ELECTRICAL ADDENDUM

Project:
CAMH 250 College relocation

ADDENDUM No. E-1

Issued: Aug 31, 2022

Date	MARCH 2023	
Scale	1/8"=1'-0"	
Drawn By	D.K.	
Approved By	P.C.	Drawing No. C2.1
File No.		
Project No.	22048

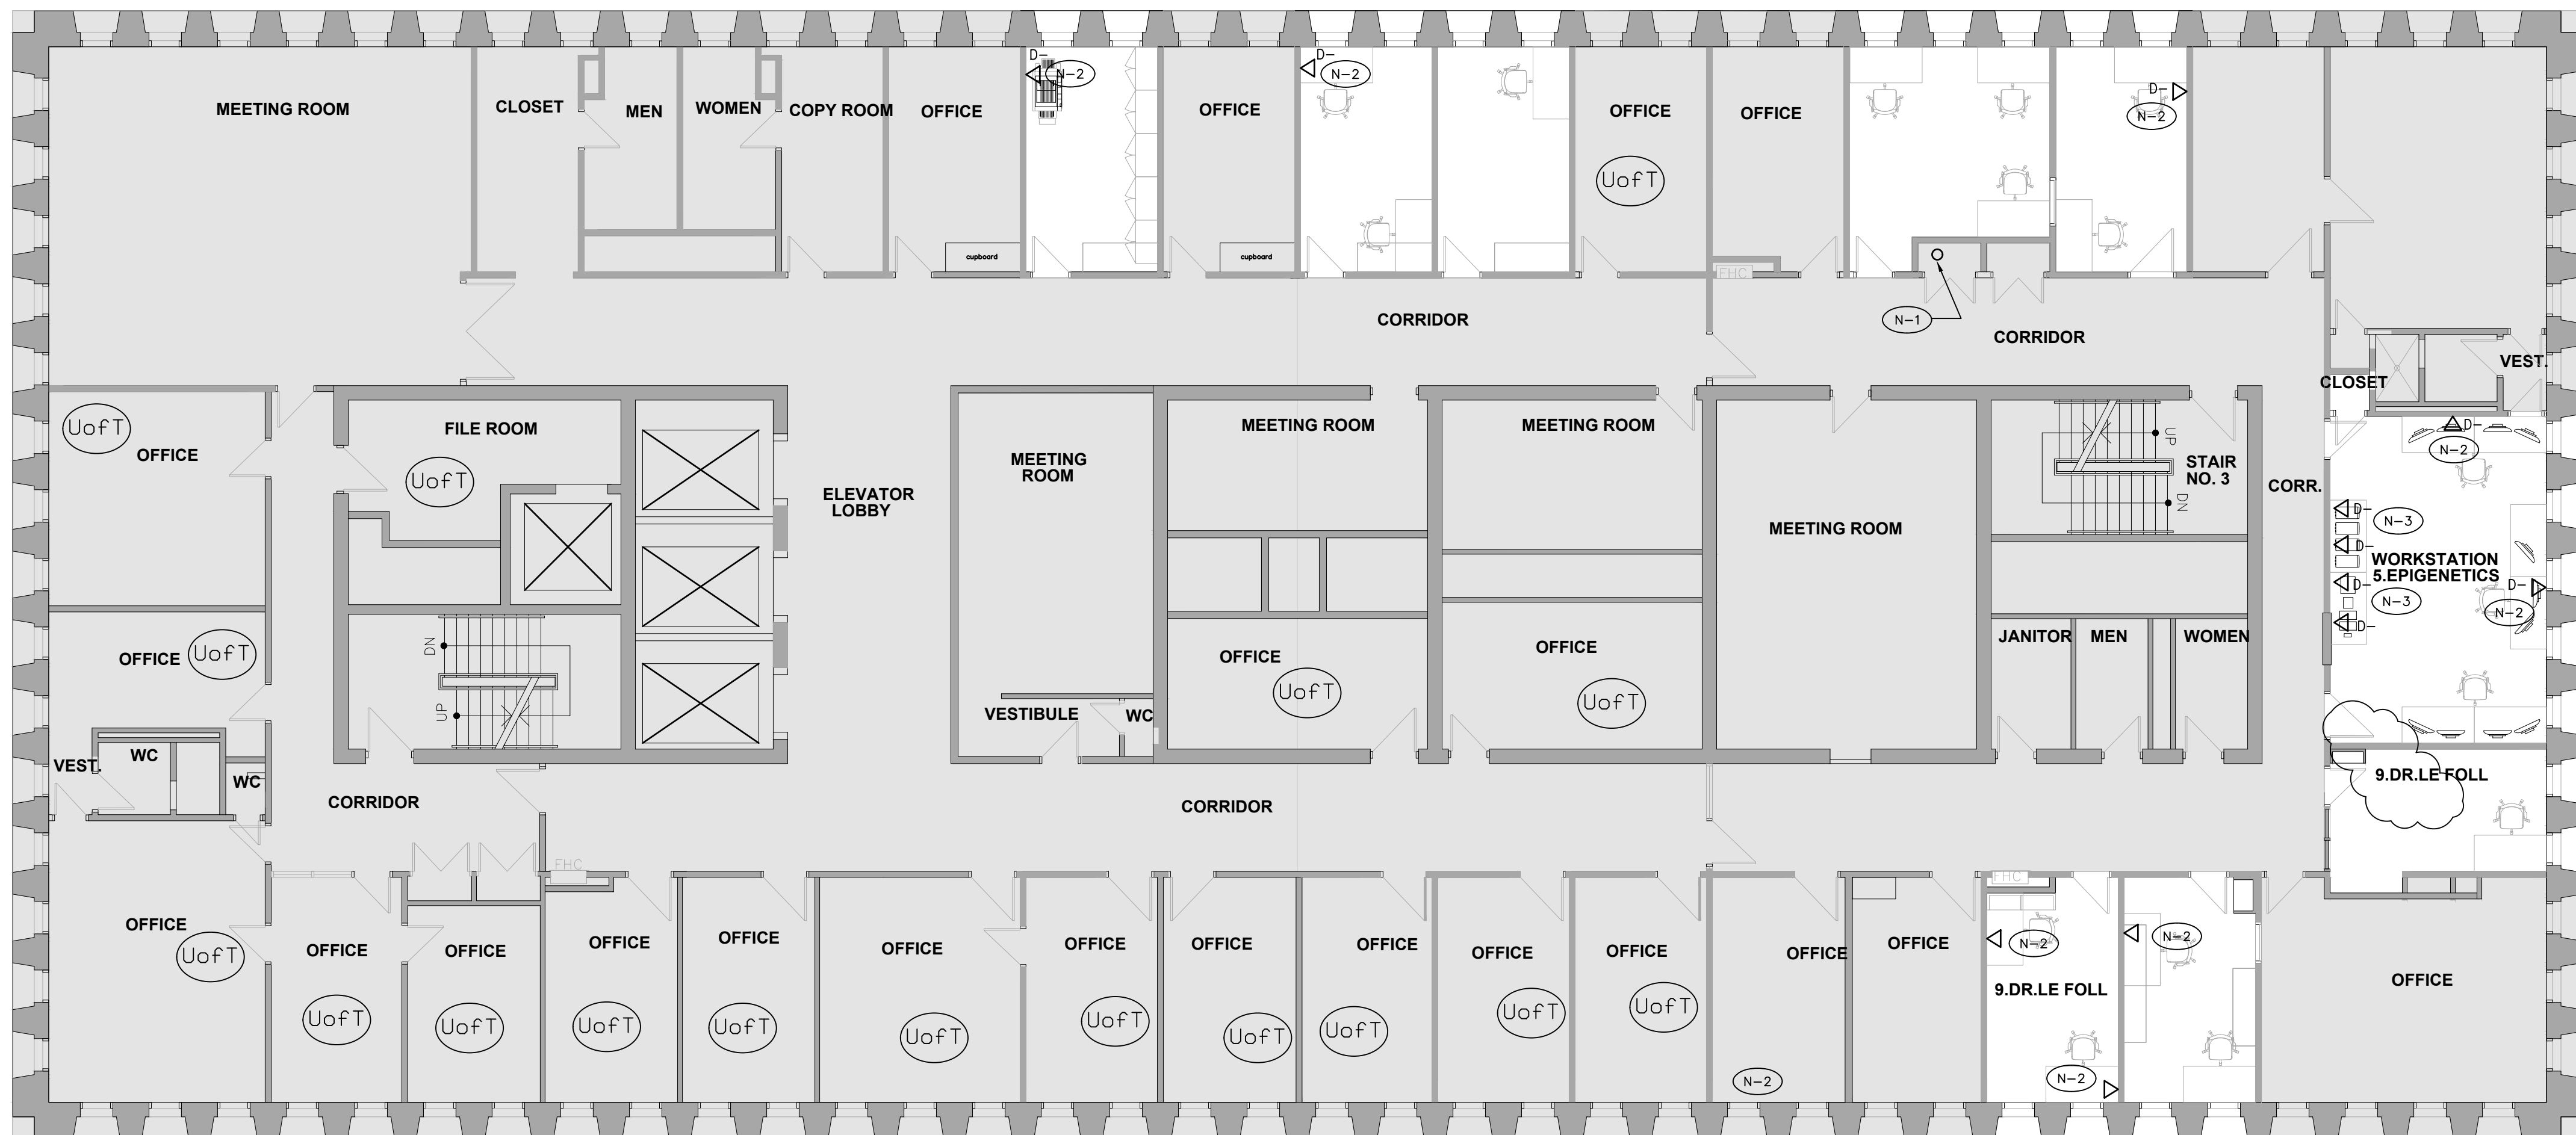
- a) Clarification on patch cord requirements,
 - a. All patch cords at new rack and all patch cords at workstations, are to be provided and installed by the electrical/comms contractor.

- b. Patch cords at rack are designated as 12" length.
 - c. Patch cords at workstations are designated as 12' in length.
- b) Clarification on allowance for 10% of defective or nonoperational outlets, refer to demolition drawings E3.00, E3.02, E3.04, E3.06, E3.08 & E3.10 for existing outlets to be maintained.

- c) Clarification, all new data outlets are to be wired to new rack located on 9th floor in room 950.
- d) Clarification, delete reference to swing out rack, unit is a 4 post fixed type.

- e) Clarification, new fibre backbone and tie cable shall consist of 6- 50/125 micron multimode strands of laser optimized, OM4 cable to certified to support 10G Ethernet at 500 m. Fibre backbone cable must be installed in conduit as required for an active air plenum ceiling. Plenum-rated innerduct is acceptable.

- f) All terminations shall be SC type.
